Comments Re: Planning Application: 261863 Mallards, School Road, Hurst, Wokingham RG10 0DR

No objection to the proposed fenestration changes detailed on submitted document **PLANNING PLANS PROPOSED ELEVATIONS 261863 07/08/2026**, subject to clarification. The previous design for 3 dormer windows was actually approved by the Planning Inspectorate (Appeal Ref: APP/X0360/A/08/2065511).

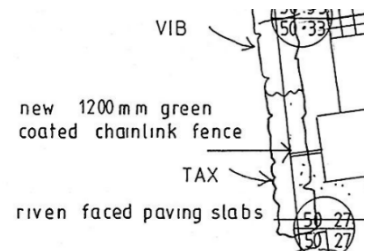
(3) A recent August 2026 photo of Mallards indicates trees south and west of the property currently growing nearby and also within the property, and within falling distance.

Starting on the left:

- 1) Hollyoaks to the side access path,
- 2) A conifer “Golden Rider” in line with the ridge,
- 3) An unruly Ash towering above the ridge to the left of the dormer windows,
- 4) Tips of the veteran oak T1 just visible above the ridge,
- 5) And to the right to the left of the telegraph pole beyond the garage, a younger oak.

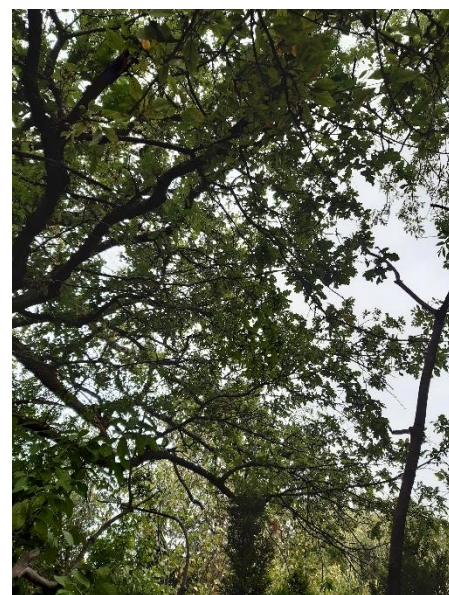
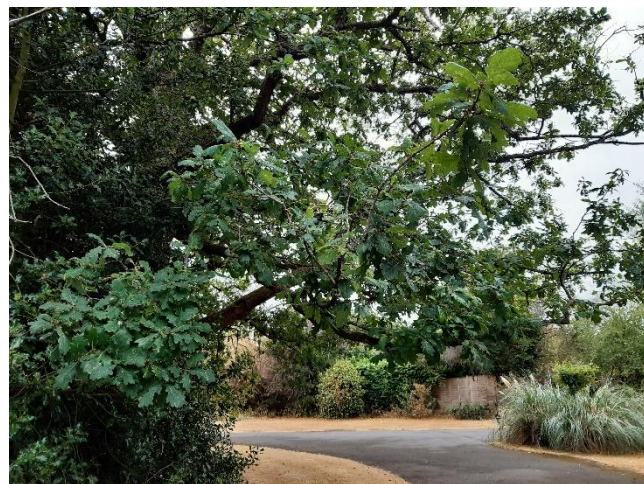
A screenshot (right) from App: C/2011/2396 09/2011 BOUNDARY TREATMENT Dwg COND 1/A, proposes a new fence on an agreed boundary line. Rather than the specified chainlink fence between the sidegate post and the School Road pavement, a rustic post and rail fence was erected. This has since been removed with rails currently stored against veteran oak T1. It would be both helpful and neighbourly to reinstate Mallards’ boundary fence to avoid any confusion as to what vegetation is overhanging and what is not.

(3.2) The conifer (Golden Rider), growing more than 1m inside Cherry Trees/Cranford Drive boundary, and currently hiding the visually intrusive higher-built gable end of Mallards, helps to enhance the leafy, open, rural amenity value of Cranford Drive. This tree will block any views from the proposed southwest windows across private Cranford Drive and as owners we have no wish to either remove it or reduce it in height. Obviously, any trimming or pruning would need to be seasonal and sympathetic to wildlife with collared doves previously discovered nesting in this tree resulting in aborting work.

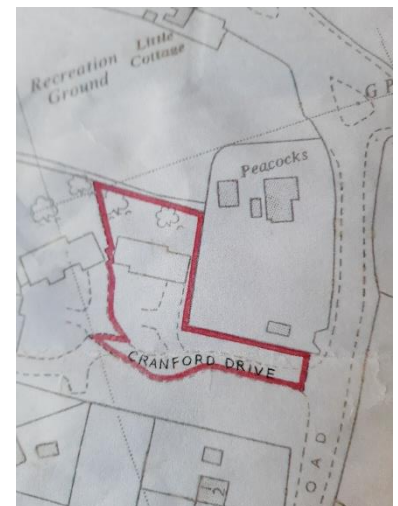
Referring to NEIGHBOURING H.M. LAND REGISTRY Title Number BK129438 overall detail pictured (right) the detailed marked-up title plan shows the actual Cranford Drive/Mallards boundary south of the rustic brick wall end, positioned slightly west of the overall approximate red boundary indicated on the small general plan (right). The previous owner fenced off this strip in line with the wall, which became effectively a no-man’s land, and it is in this strip the “12m/13m” oak is growing.

We have no objection to the new owners of Mallards moving their chain link fence on the western boundary closer to Cherry Trees green, wooden, plant support lattice and fence to recover, and take proper ownership of this strip – strictly in accordance with boundary details specified in BK129438 (dating from 1974).
